UR Family

Version 8.1x

Release Notes

Publication reference: GER-4903D

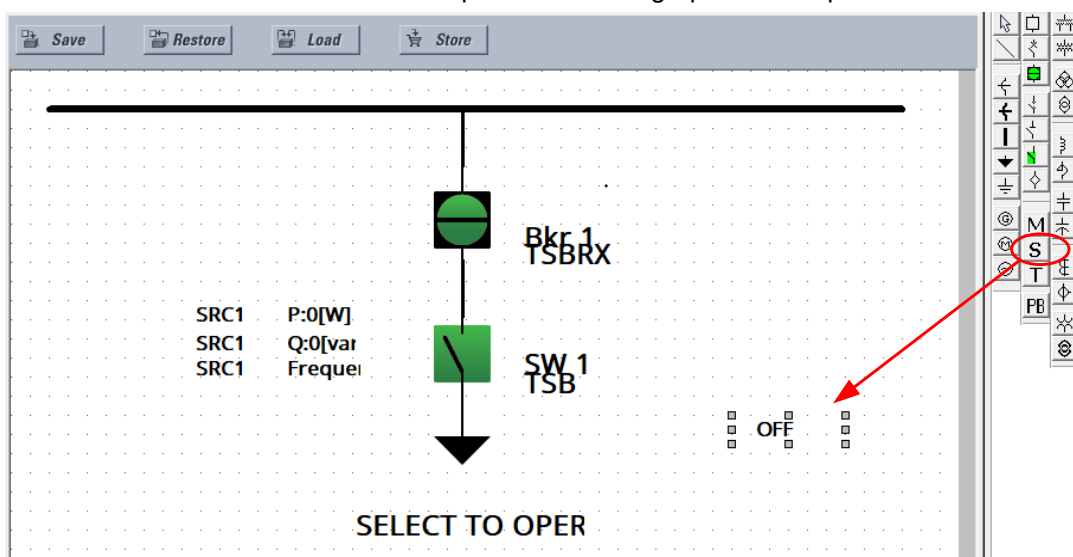
Description: After converting a device from version 7.80 or earlier to version 8.10, in some situations certain FlexLogic equation inputs were defaulted in diagrams even though the equations were correctly displayed in the FlexLogic Editor screen.

The new release requires users to compile their logic designer diagrams before executing the device conversion. This preliminary operation allows EnerVista UR Setup software to properly show Logic Designer diagrams in the converted device, based upon the correctly converted equations and the (now) guaranteed synchronicity between equations and diagram.
